**City of Bellevue
Development Services Department
Land Use Staff Report**

Proposal Name: Petrescu Retaining Wall

File Number: 13-111805-LO

Subject: Slope Restoration and Ecology Block Wall Recommendations
16710 SE 34th Street
Bellevue, Washington

Attachment: Figure 1 - Grading Mitigation and Revegetation Plan

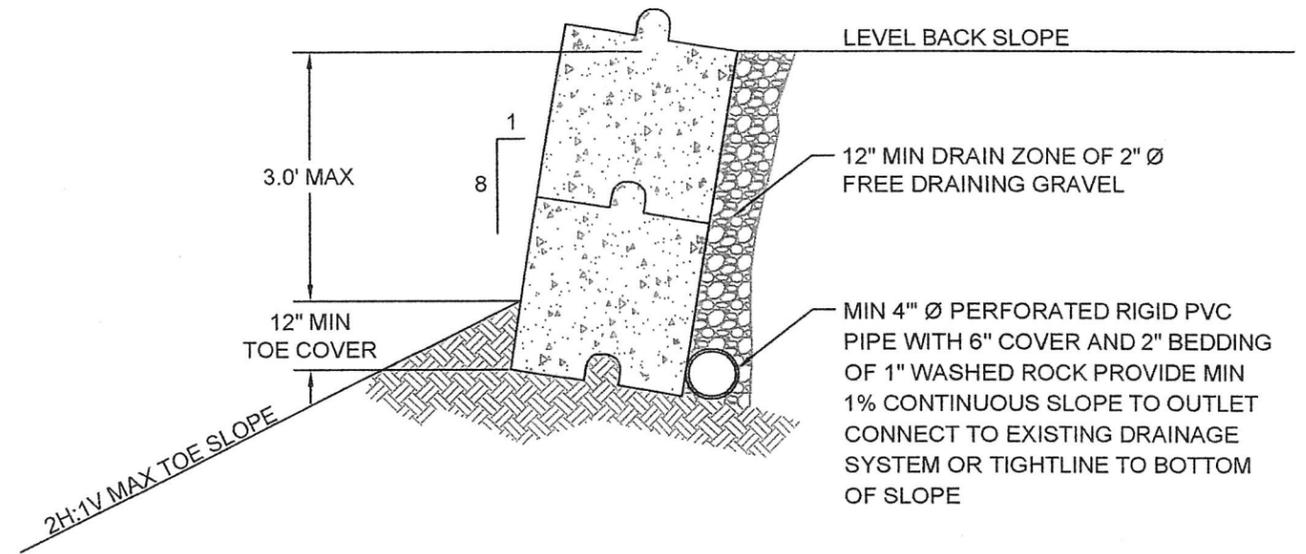
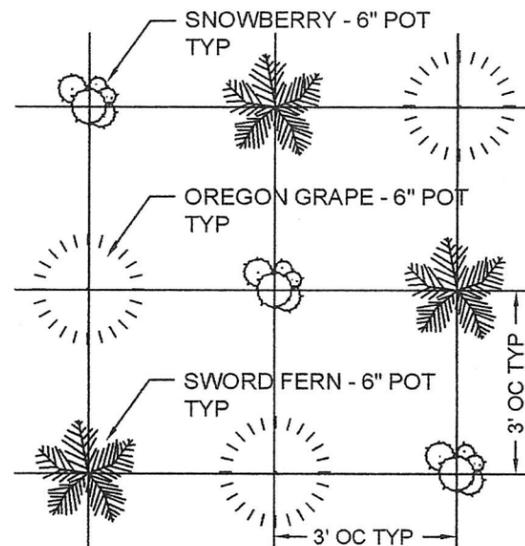
Based on our observations, we recommend that drainage elements be incorporated into the existing ecology block wall, along with a moderate amount of remedial grading followed by revegetation of the slope with erosion-resistant plantings. Figure 1 shows the existing residence and the area of the recommended mitigation measures. Based on our limited site and document review, we have the following comments:

- Figure 1 includes a recommended detail for the existing ecology block wall. A minimum 1-foot-wide blanket of 2-inch-diameter drain rock should be placed along the back face of the ecology block wall. A 4-inch-diameter, perforated drainpipe should be placed at the base of the drainage zone and routed by gravity to a suitable discharge. If not tied to the existing house drainage system, the wall drainage should be tightlined to the bottom of the existing slope east of the wall.
- We recommend that the affected portion of the slope below the ecology block wall be regraded to a maximum slope of 2H:1V, with the resulting ground surface compacted to a firm condition. Excess soil should be removed from the slope area. The distances shown on Figure 1 from the wall and recommended mitigation area to the residence should be considered approximate.

- Figure 1 includes a planting plan with recommended plant species. Temporary erosion and sediment control (TESC) measures for the recommended mitigation area are also recommended. For most sites with active grading, the TESC measures include a perimeter silt fence. Since the “grading” at this particular site will be limited to regrading the upper portion of the slope and the placement of potted plants, we consider the trenching associated with silt fence installation to create a greater impact than the proposed re-planting activities. Instead, we recommend that the sequence of planting is arranged such that the plants planned for the lowest portions of the mitigation area are planted first. As these plants are placed, we recommend that bark mulch be spread in the low areas to provide a temporary erosion control perimeter for the re-planting area. Subsequent planting and mulching can then continue upslope through the mitigation/ revegetation area.

- i. A minimum 1-foot-wide blanket of 2-inch-diameter drain rock should be placed along the back face of the ecology block wall. A 4-inch-diameter, perforated drainpipe should be placed at the base of the drainage zone and routed by gravity to a suitable discharge. If not tied to the existing house drainage system, the wall drainage should be tight-lined to the bottom of the existing slope east of the wall.

- ii. We recommend that the affected portion of the slope below the ecology block wall be regraded to a maximum slope of 2H:1V, with the resulting ground surface compacted to a firm condition. Excess soil should be removed from the slope area. The distances shown on Figure 1 from the wall and recommended mitigation area to the residence should be considered approximate.

- iv. Temporary erosion and sediment control (TESC) measures for the recommended mitigation area are also recommended. For most sites with active grading, the TESC measures include a perimeter silt fence. Since the "grading" at this particular site will be limited to regrading the upper portion of the slope and the placement of potted plants, we consider the trenching associated with silt fence installation to create a greater impact than the proposed re-planting activities. Instead, we recommend that the sequence of planting is arranged such that the plants planned for the lowest portions of the mitigation area are planted first. As these plants are placed, we recommend that bark mulch be spread in the low areas to provide a temporary erosion control perimeter for the re-planting area. Subsequent planting and mulching can then continue upslope through the mitigation/revegetation area.
